Madura Dist^t Magistrate's Office
24th March 1882.

With reference to your letter
N^o 870, dated 25th February 1882, I
with 2 vouchers have the honor to forward Account
Current and schedule of expenditure
for the months of August and
November 1881 for the repair of Sub
Magistrate's Quarters and Sub Jail
at Tirupatur, with the completion
certificate appended to the schedule
of the latter month.

I beg to report regarding the completion of the repairs to the Sub Jail and Sub Magistrate's Cutcherry at Tirupatur.

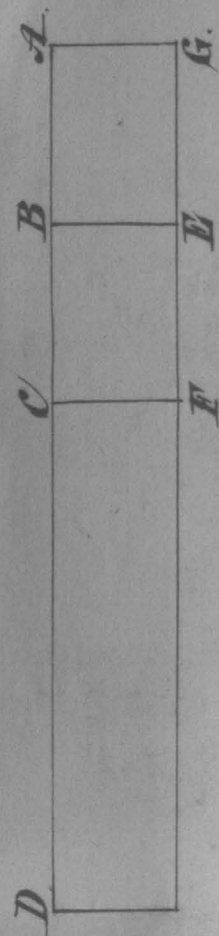
3. The estimate has provided for the flooring of the front verandah. At the time when the estimate was prepared, there was a small room at the northern end of this verandah, whose southern wall was merely the continuation of the southern wall of the record room. Subsequent to the estimate and before the repairs were commenced the wall appears

appears to have been knocked down, and the room enlarged by taking up a portion of the veranda. The marginal sketch illustrates the above. The present room on the veranda is A, F, while the former was A, E. B, F, was thus included before in the veranda, and the flooring of it is provided for in the estimate. I had therefore either to order the flooring of the whole A, F, or leave it ^{out} altogether. I thought the former course was better, inasmuch as the room is required for the Sub-Registrar, and there ought to be some flooring or other. The extra cost thereby incurred is only Rs. 6-6-4.
